Jamuna Knit Concern. Patriot Fashion Ltd.

Observations

Observations: Factory Building

Column to be stressed above normal design limits

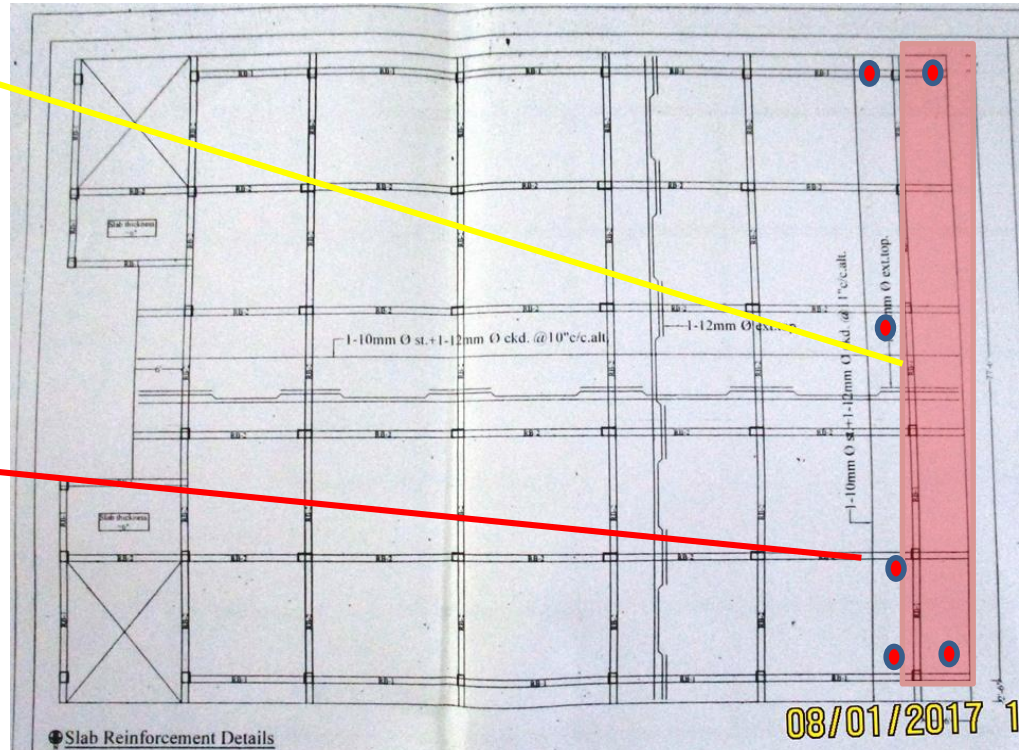
Cantilever at west with toilet area

Cursory calculations indicate that the working stress of the ground floor columns are at a level that requires immediate design review.

Plastic water tank on roof

Slab and beam details

Item No.	Observation	Recommended Action Plan	Recommended Timeline
1	Column to be stressed above normal design limits.	Verify in-situ concrete strength and aggregate type from min. 4 no. 100mm dia. core samples from columns.	6-weeks
2	Column to be stressed above normal design limits.	Factory Engineer to review design, loads and columns stresses.	6-weeks
3	Column to be stressed above normal design limits.	Produce and actively manage a loading plan for all floor plates within the factory, giving consideration to floor capacity and column capacity.	6-weeks
4	Column to be stressed above normal design limits.	Continue to implement loading plan.	6-months
5	Discrepancies between provided drawings and on site condition	Building Engineer to survey as-built structure and prepare accurate as-built survey information, including all columns, beams and slabs.	6-weeks

Discrepancies between provided drawings and on site condition

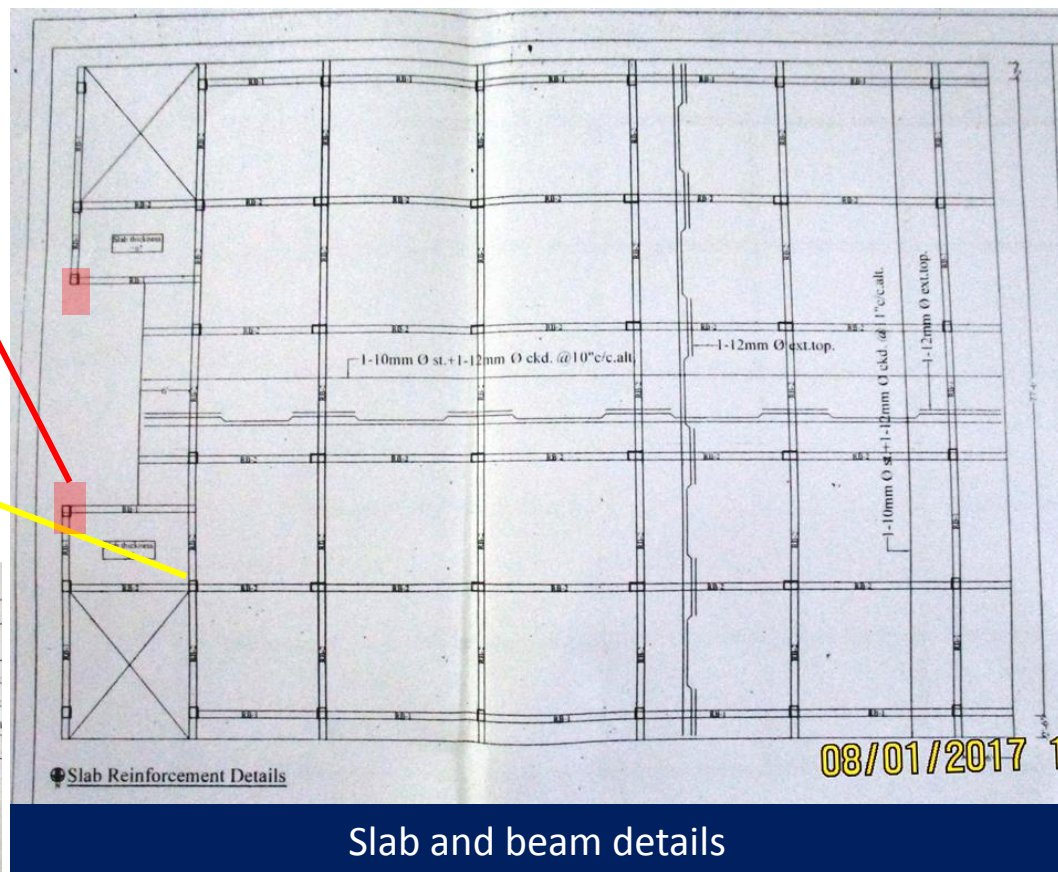
Column layout didn't fully matched with as built condition. Also (corner & stair) column size and nos. of rebar were not matched with column schedule. At east side two columns are not found and which is marked as red on drawings.

Both beam slab and flat slab were shown in provided structural drawing. But during inspection flat slab found in all floors.
